IEEE 802.3 Maintenance

July 21st, 2005
San Francisco, CA

Activities this week

1168 - Comparison of requirements

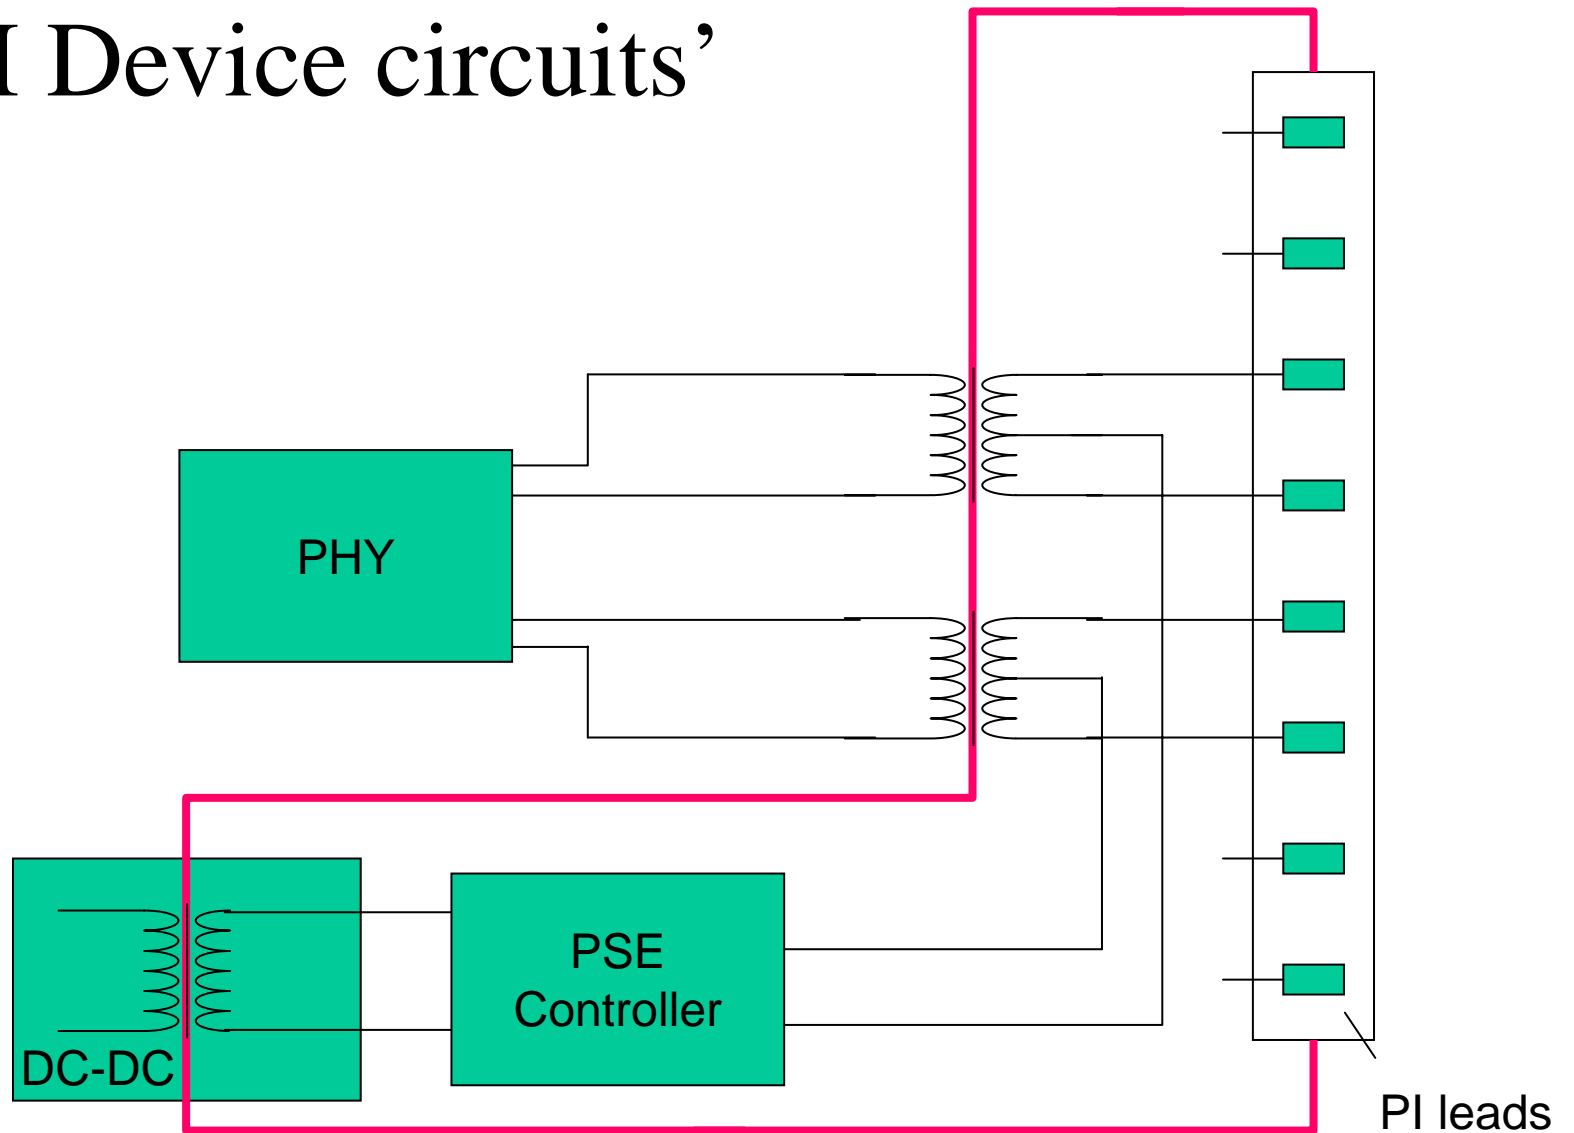
Isolation from all MDI leads to	AC and DC test			Impulse test	
		Vrms	Vdc	Test method	Impulse	Defined
10BASE-T	Frame ground and PHY device circuits	1500V	2250V	5.3.2 of IEC 60950:1991	2400V 1.2/50 us	IEC 60060
10BASE-T The PI of a PD within its MDI	Frame ground and all external conductors					
100BASE-T ^{Note1}	Frame ground	1500V	2250V	5.3.2 of IEC 950:1991	2400V 1.2/50 us	IEC 60
1000BASE-T	Frame ground and PHY device circuits	1500V	2250V	5.3.2 of IEC 60950:1991	2400V 1.2/5 us	IEC 60060
1000BASE-T The PI of a PD within its MDI	Frame ground and all external conductors					
DTE Power via MDI	PI Device circuits	1500V	Not allowed	6.2 of IEC 60950-1:2001	1500V 10/700 us	6.2.2.3 of IEC 60950-1:2001

'PI Device circuits'
